ADDENDUM NO. 2

Contract: 6-C-23; Manhole Rehabilitation of Adamo, Clark and Sligh Interceptors
Bidders on the above referenced project are hereby notified that the following addendum is made to the Contract Documents. BIDS TO BE SUBMITTED SHALL CONFORM TO THIS NOTICE.

MANHOLE REHABILITATION OF
ADAMO, CLARK AND SLIGH INTERCEPTORS
CAST IRON FRAME & COVER REPLACEMENT DETAIL
(NOT TO SCALE)

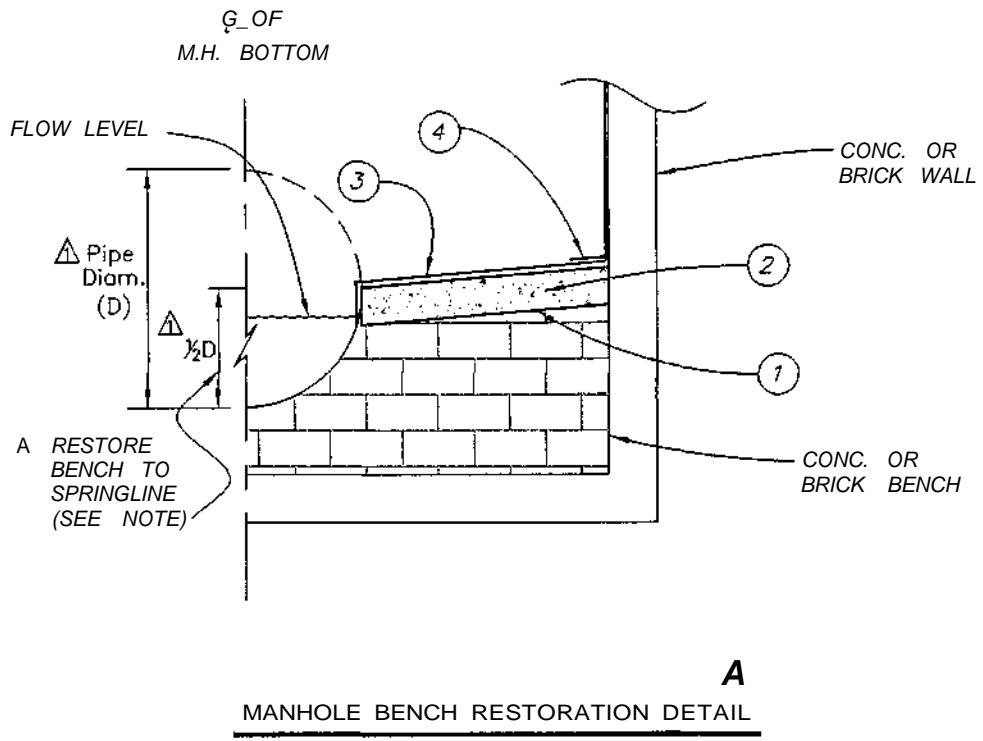
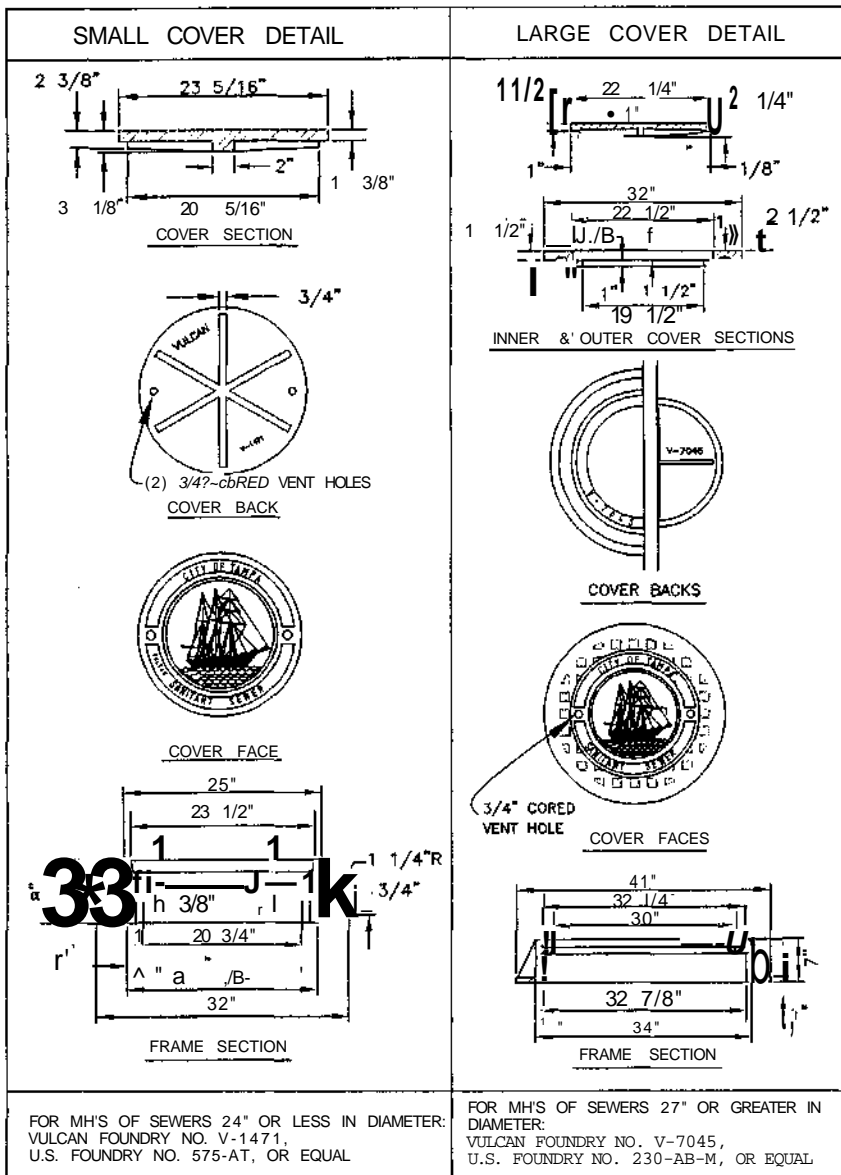
Item 4: Replace plan sheet 24 of 24 with the attached sheet 24 of 24.

No.	DATE	REVISIONS	No.	DATE	REVISIONS	DES: J.F.
3			6			DRN: R.A.R.
2			5			CKDif?2?<"
A	07/26/06	REVISED MANHOLE BENCH RESTORATION DETAIL.	4			DATE ^-%/^

- (7) REMOVE ALL DEBRIS AND LOOSE
- (2) INSTALL A MINIMUM 1" THICK CL... ALLOW CONCRETE TO CURE (MIN... BY THE ENGINEER).
- (1) OVERLAY BENCHES WITH PROPOS
- (7) PROVIDE 6" COATING THICKNESS IS INCLUDED IN THE BOTTOM CH

A NOTE:
EX/STING MANHOLE BENCHES OF CORRODED AND/OR ERODED BEL PIPE. BENCHES SHALL BE RES1 WORK MAY REQUIRE THE INSTALL DURING LOW FLOW PERIODS.

LOOSE BRICKS FROM THE TOP OF THE BENCH.

LOCK CLASS "D" CONCRETE OVER EXISTING BENCH.
CURE (MIN. 24 HRS. UNLESS OTHERWISE APPROVED)

PROPOSED COATING SYSTEM.

KNESSE TRANSITION. PAYMENT FOR THIS ITEM
FROM CHAMBER COST PER SQUARE FOOT.

COVERS OF THE CLARK INTERCEPTOR MANHOLES HAVE
BEEN RESTORED TO THE SPRINGLINE (1/2" DIAMETER) OF THE
PIPE RESTORED TO THE SPRINGLINE AS SHOWN. THIS
INSTALLATION OF A FLOW-THRU PLUG OR WORKING
COVER IS REQUIRED.
